PURPOSE OF ISSUE		
PLANNING		
PROJECT		
WINSLEY PADDOCK		
SHEET		
PROPOSED GF PLAN		
Date	Drawn by	Checked by
08/08/25	CM	CM
Project number	Scale (@ A3)	
LAMA-56	1 : 100	
DRAWING NUMBER		REV
L110		P07

PROPOSED GROUND FLOOR PLAN
1 : 100

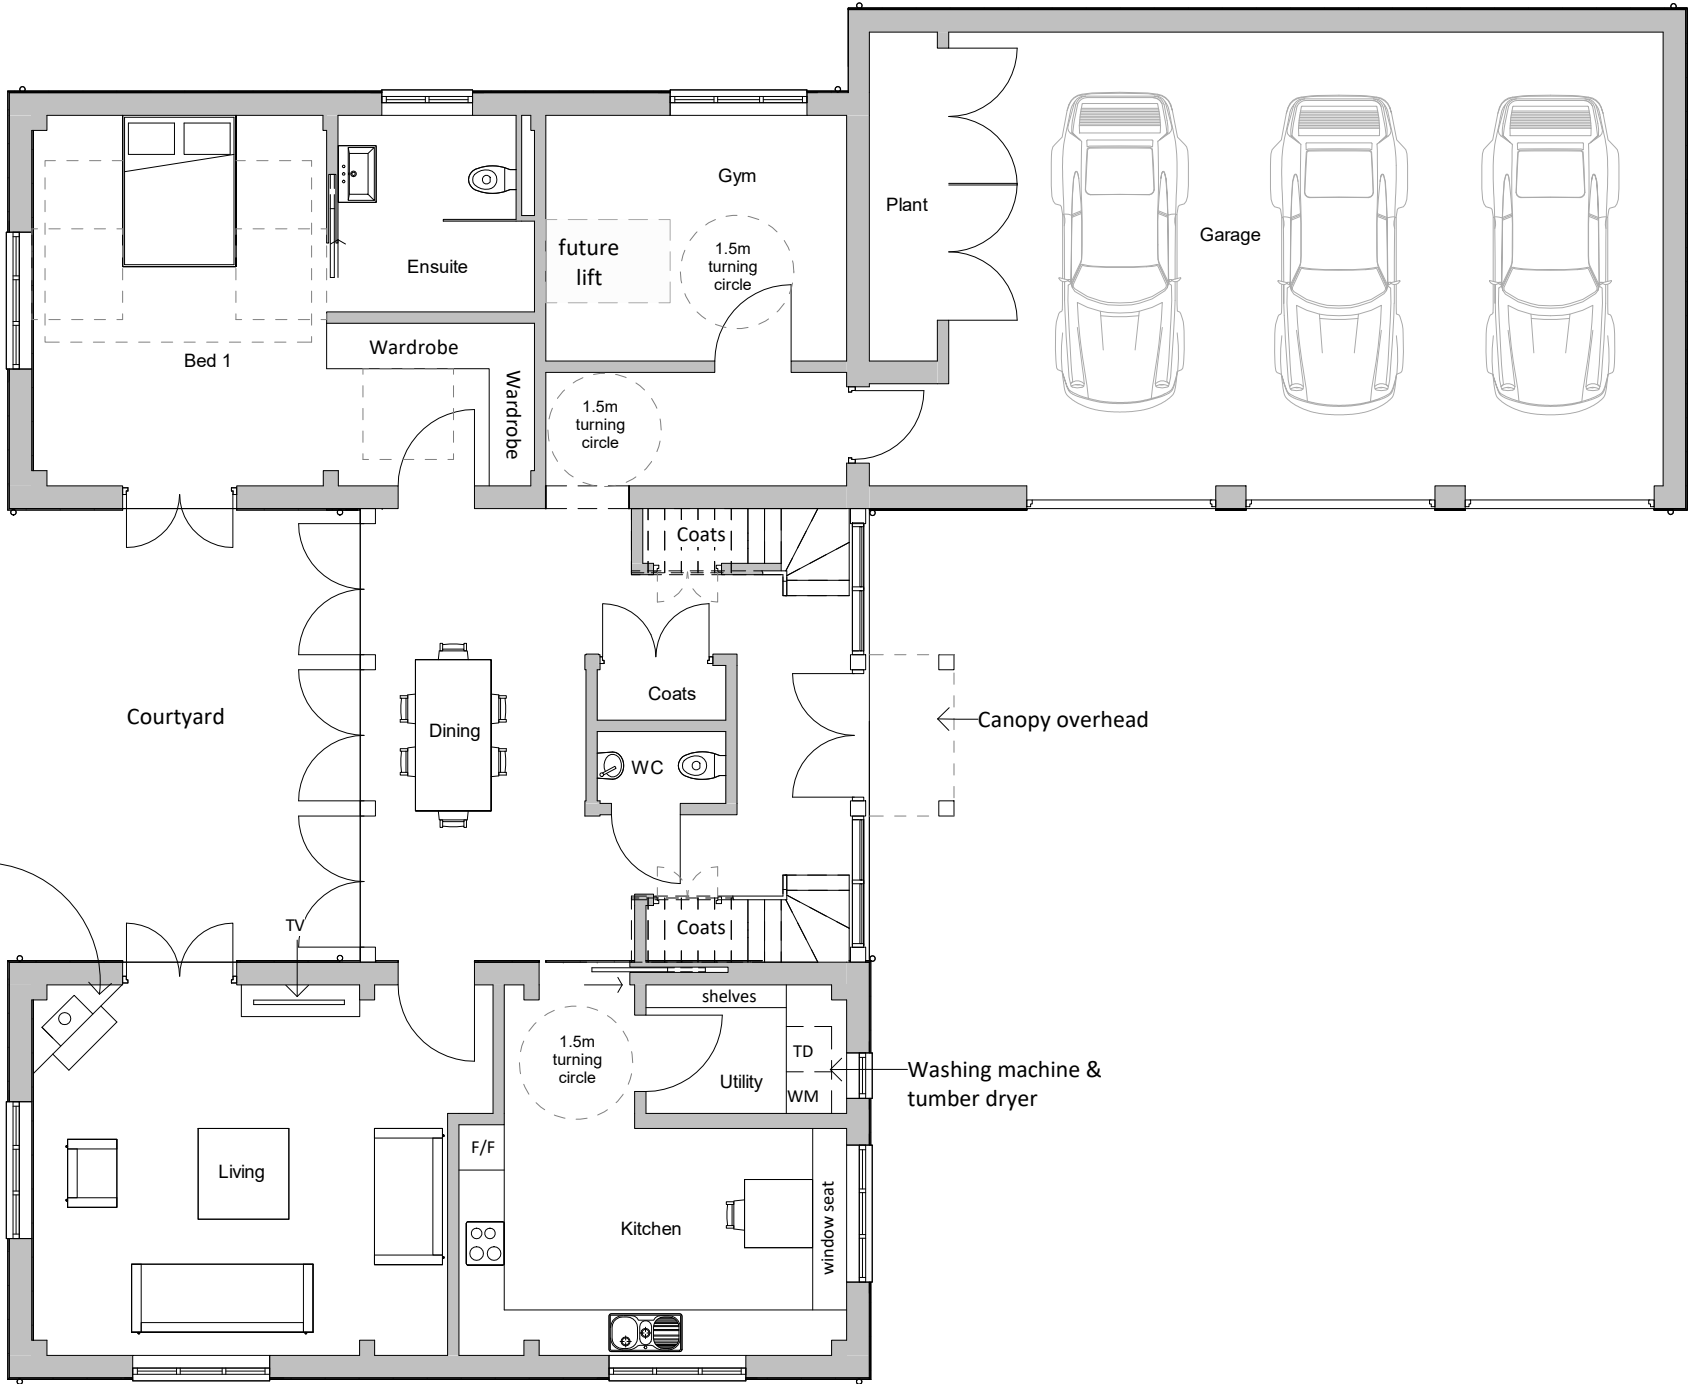
No.	Description	Date
P05	Fenestration updated. Fencing omitted.	27/08/25
P06	Roof pitch adjusted. Floor plan and fenestration adjusted for oak frame	16/09/25
P07	Changes to internal walls and fenestration due to oak frame	25/09/25
